Recommendation Report Detailed Planning Analysis

Owner: 2828778 Ontario Inc.
 (previously identified as Starbank, Stellarcorp & Plazacorp)

420 Lakeshore Road East

Adjacent properties would benefit from a reduction in the proposed height

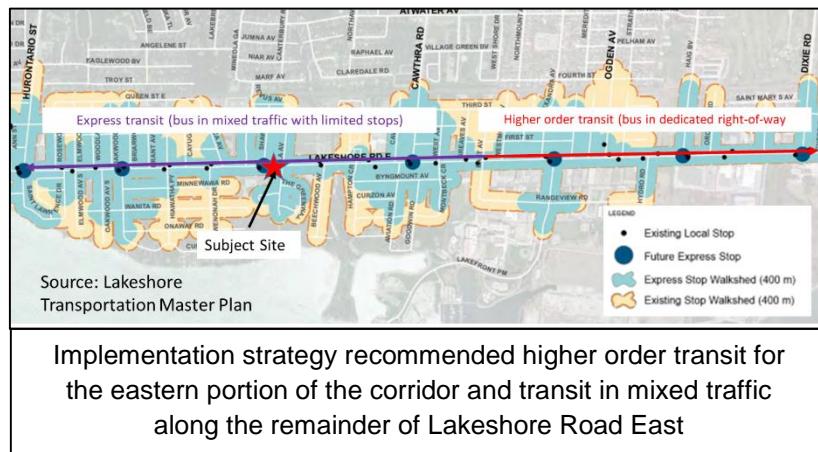
- The building massing would benefit from further refinement to reduce shadows on the residential lots immediately abutting the development.

- The building massing would benefit from reduced floorplates for floors seven and above. Currently the proposed seventh floor has a gross floor area of 1 208 m² (13,003 ft²) whereas the Lakeview Built Form Standards indicate that buildings between 7 and 14 storeys will have a maximum floor plate of 1 000 m² (10,764 ft²), including balconies, to ensure minimal impact on adjacent low rise residential and to maintain sky views.
- The location or design of the building entrance at the corner of Lakeshore Road and Enola Avenue is not appropriate and needs to be addressed in order to mitigate the wind condition. Additional information is required to confirm the

extent of wind conditions that will be created by the building on the public right-of-way.

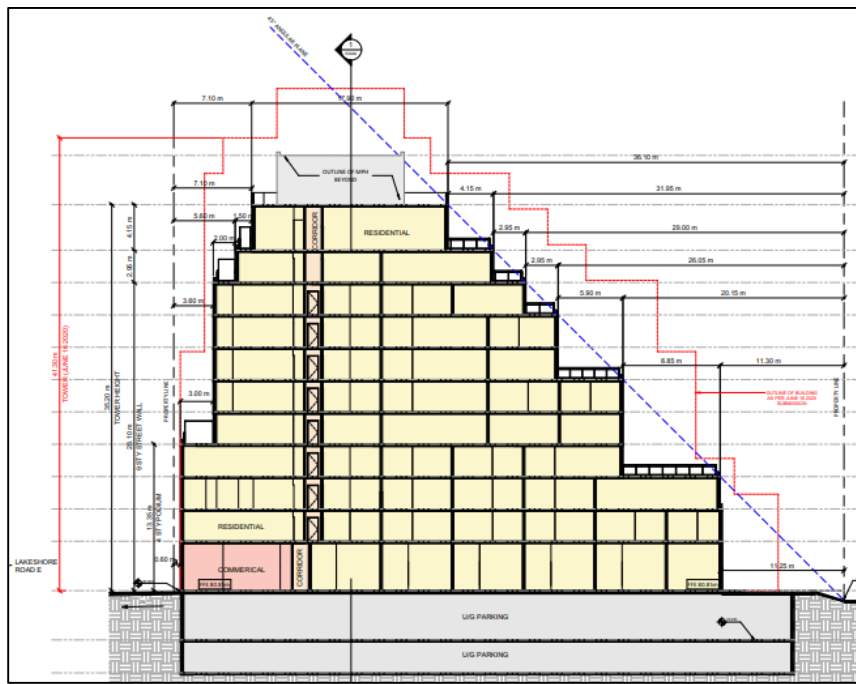
Preliminary draft policy recommendations released at a virtual community meeting on June 10, 2021 indicate that an appropriate height for larger lots (greater than 40 m in depth) along this corridor could be a maximum of 8 storeys assuming:

- an appropriate transition that respects a 45 degree angular plane for adjacent residential lots
- a stepback of 3 m (9.8 ft.) after the 4th floor
- a minimum setback of 0.6 m (2.0 ft.) from the property line on Lakeshore Road East

The subject site's proposed 11 storey height exceeds this recommendation, although the proposed building respects the 45 degree angular plane, fourth floor stepback and minimum setback from Lakeshore Road East

Massing of the building has been reduced (red line represents previous version) and building is now within 45 degree angular plane from property line

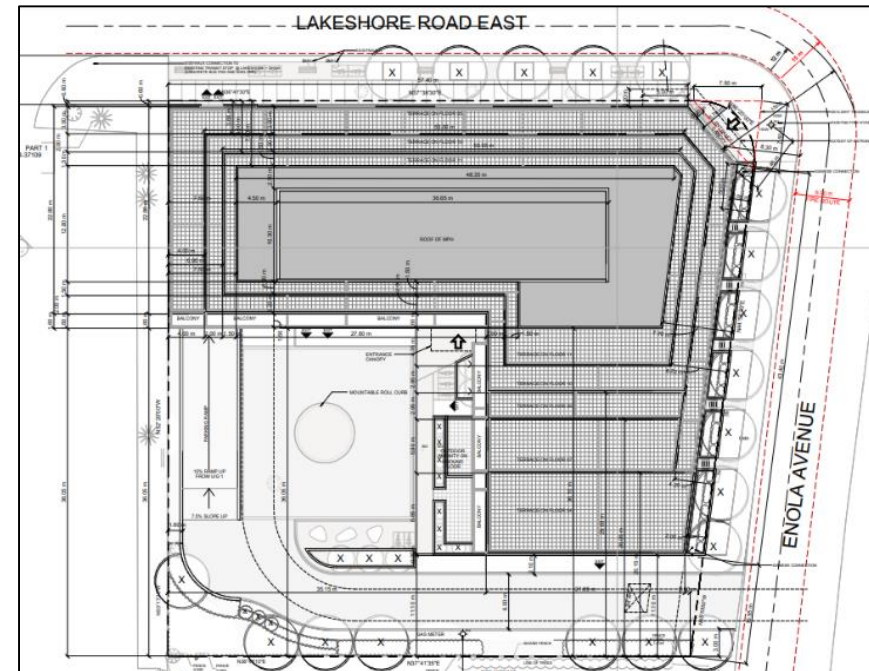
- The proposed height has been reduced from 12 storeys (41.3m) to 11 storeys (35.2 m)
- The building floor plates have been reduced which results in the Floor Space Index being reduced from 4.96 to 3.73
- The number of units has been reduced from 195 units to 166 units
- The development now meets the 45 degree angular plane from the rear property line

- The live/work units have been replaced with commercial uses and indoor amenity space at grade
- Additional parking has been included so that the proposed parking rate has increased from .95 spaces per unit to 1.15 spaces per unit (including visitor parking)
- The driveway entrance from Enola Avenue has been relocated from the middle of the property to the southern end of the site
- The proposed outdoor amenity space been revised to reflect the revised driveway layout

The driveway entrance has been relocated from mid-block to the southern end of the property
